ADDENDUM COVER SHEET

Addendum No. 1

Chew Playground Field Renovations RFP (1800 Washington Ave.)

Philadelphia Redevelopment Authority

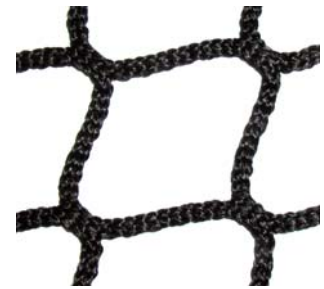
1. Is there a start date for the project?
 - We are looking to commence the project mid-May.
2. Can we receive the GPR Report on the UST ?
 - Please see answer for question #4 below which depicts approximate size/depth of the UST

- All soil investigation data has been implemented into the Contract Documents
4. For the UST removal is there any site restoration needs? Please define. How would you like bidders to price the removal of the UST located north of the pool. The tank has an unknown use and the size is unknown. Should we base the removal on a specific size and content?

- The potential UST is estimated to be 5 feet in diameter and 9 feet long (approx. 1,500 gallons) and is estimated to be located 3.5 feet below grade. This has not been field verified. The contents are likely petroleum based, but again, this is not confirmed. During excavation, the Environmental Engineer will determine if the tank needs to be registered due to its contents and if there appears to be leakage. If the tank needs to be registered, the Environmental Engineer will file the documentation for this and its disposal, and the Contractor will be responsible for cleaning and disposal.

If the Environmental Engineer determines the tank has leaked and the soil below it needs to be removed, the Contractor will be responsible for excavating and disposing of the contaminated soil. For the base bid, assume a depth of 2-feet below the tank will need to be removed and disposed of, and also, provide a unit cost for the removal and disposal in case additional excavation is required. The above tank dimensions can be used as a reference for the possible area to be excavated, but the actual area may be larger.
